STAFF REPORT
COMMUNITY DEVELOPMENT DEPARTMENT

HEARING DATE: 3/8/2022
 TO: Mayor & City Council
 FROM: Alan Tiefenbach
 208-884-5533
 SUBJECT: AZ, PP - H-2021-0088
 Quartet South Subdivision
 LOCATION: Parcels S0434255555, S0434325410,
 S0434325867 and 3680 N. Black Cat
 Rd., located at the northeast corner of the
 N. Black Cat / W. Ustick Rd intersection.

Annexation of 67.61 acres of land with the R-8 and R-15 zoning district, and preliminary plat consisting of 229 building lots, future townhome or multifamily units, and 42 common lots.

B. Preliminary Plat (date: 1/25/2022)

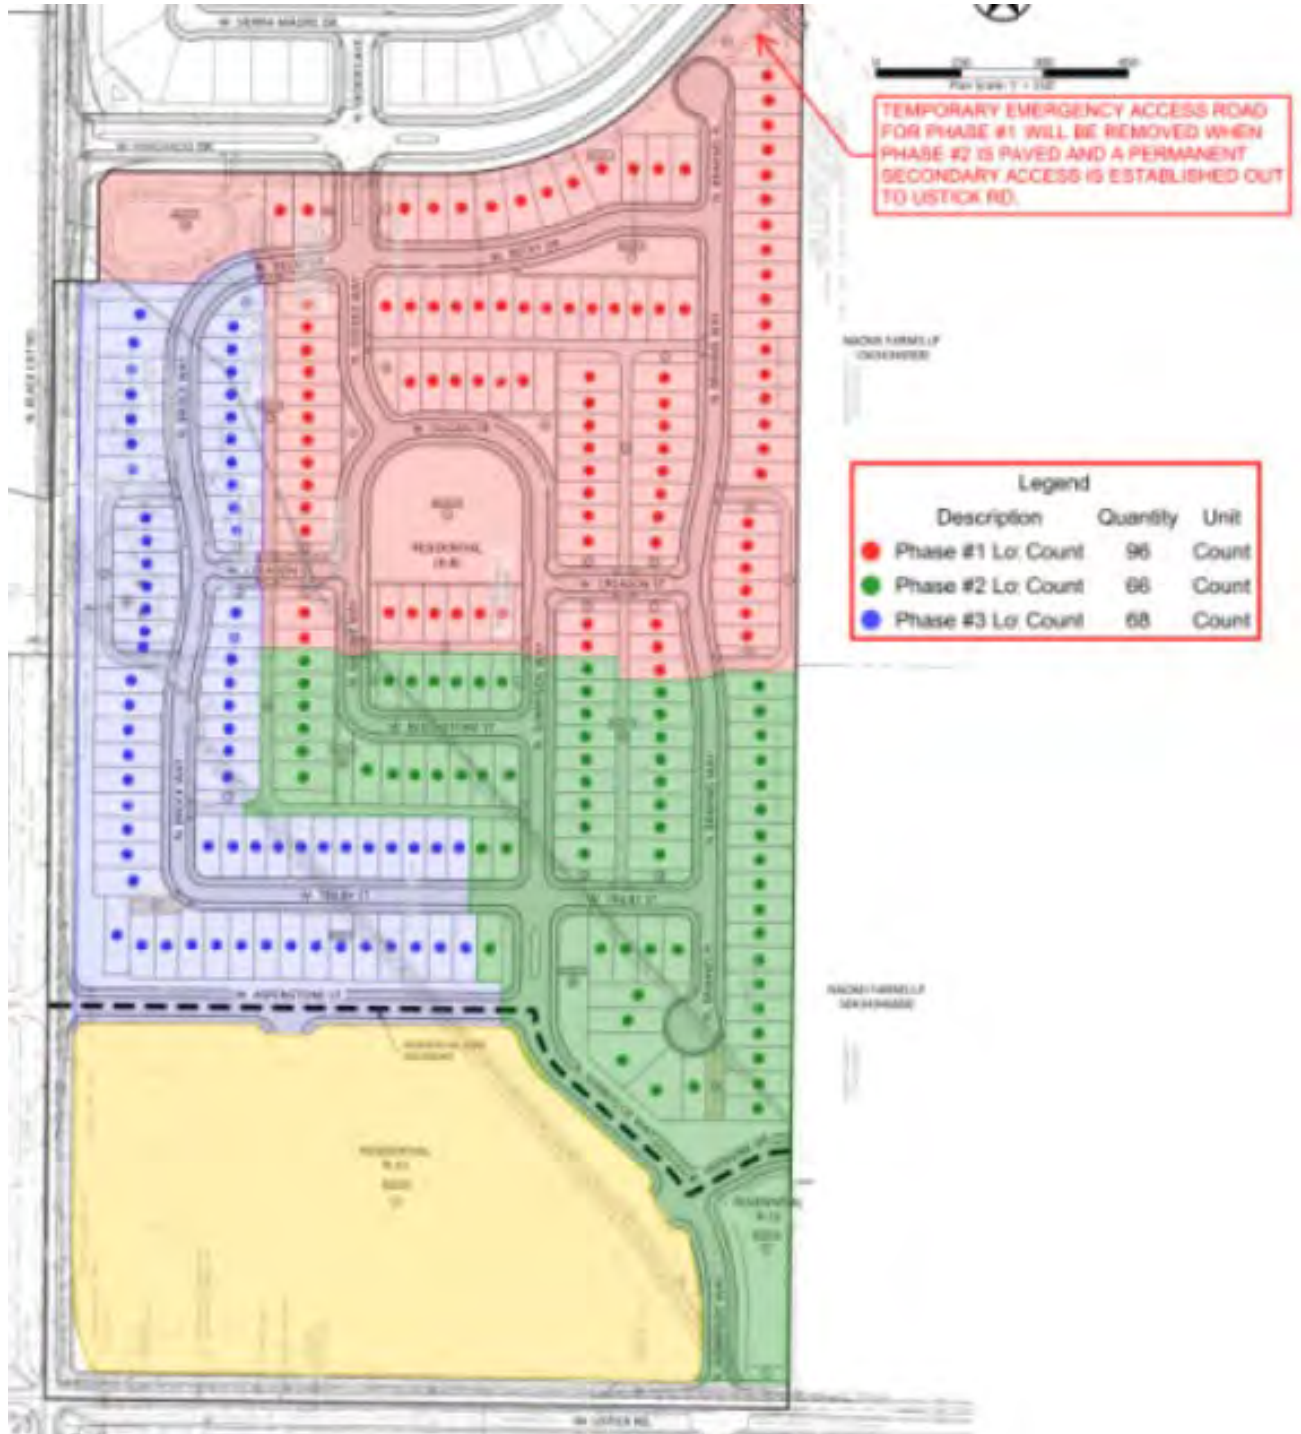
UDC 11-6C-3-B-5 states “alleys shall be designed so that the entire length is visible from a public street.” The plat reflects alleys that are aligned north – south and intersect with another alley in a “t-intersection” that does not allow visibility of the entire alley from a public street. UDC 11-5B-5 does not allow alternative compliance from this requirement. The plat must be revised accordingly, such as extending these alleys.

increase in block length to 1,000 feet if a pedestrian connection is provided. Staff has reviewed the submitted plat for conformance with these regulations. It does appear this limit is exceeded along the eastern boundary of the property. The applicant should revise the plat to meet the requirements of UDC 11-6C-3.

It does appear that the project meets the minimum open space requirements, although there are portions of Lot 13 of Block 2, Lot 7 and 43 of Block 6, and Lot 6 of Block 9 that do not meet the minimum required 20 ft. width to be credited as open space. The open space exhibit should be revised accordingly.

2. ~~The Preliminary Plat included in Section VI, dated 7/15/2021, is approved with the following revisions:~~
 - a. ~~The plat should be revised to provide a transition between the east property line and the adjacent property to the east. Staff recommends a north—south road along the eastern property line.~~

- b. ~~All alleys shall meet the requirements of UDC 11-6C-3 that requires the entire length to be visible from a public street.~~
 - c. ~~All pathways and micropath shall be within a separate common lot or easement as required per UDC 11-3A-8.~~

3. ~~The landscape plan and open space exhibit shall be revised to match the Preliminary Plat, dated 1/25/2022.~~
4. ~~Prior to City Council, the open space exhibit shall be revised to remove any areas of less than 20 ft. in width from being credited as qualified open space.~~
